SERVICE INFORMATION BULLETIN

APPLICABILITY: 2015-2017MY Legacy

NUMBER: 12-249-18

SUBJECT: Rear Body Panel- Design Change

View from inside trunk area looking upward toward underside of package shelf.

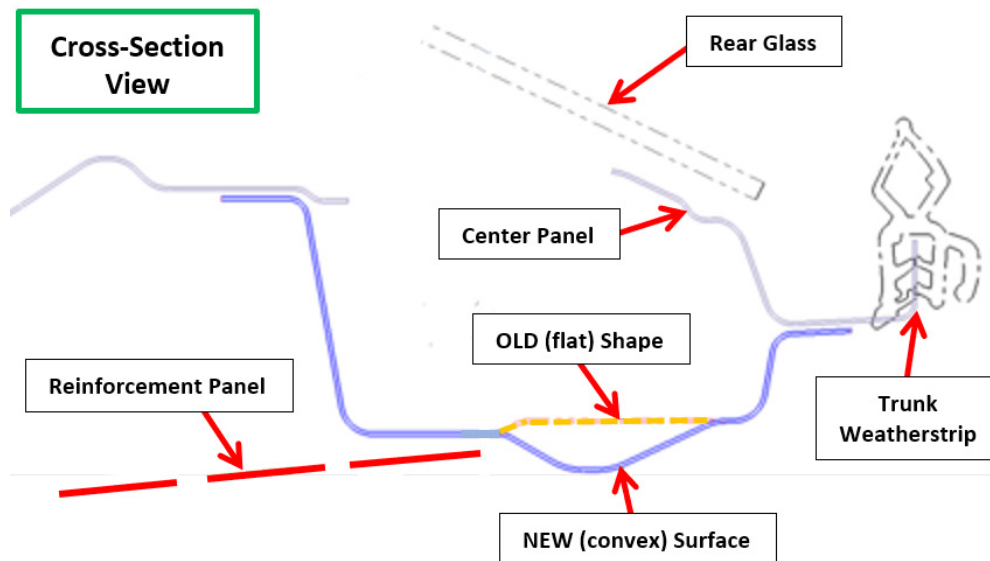
This Service Information bulletin advises of a design change made to the rear body panel. This panel is located between the trunk and the rear glass and incorporates the package shelf. It has been re-designed with 2 convex surfaces added to prevent items going into or out of the trunk from being scratched or caught by the rear edges of the reinforcement panels (shown in red) on the illustrations below.

The new part numbers for the “PANEL COMPLETE R” are **53105AL02C9P** and **53105AL03C9P**. Always order the most up-to-date part as specified by the VIN.
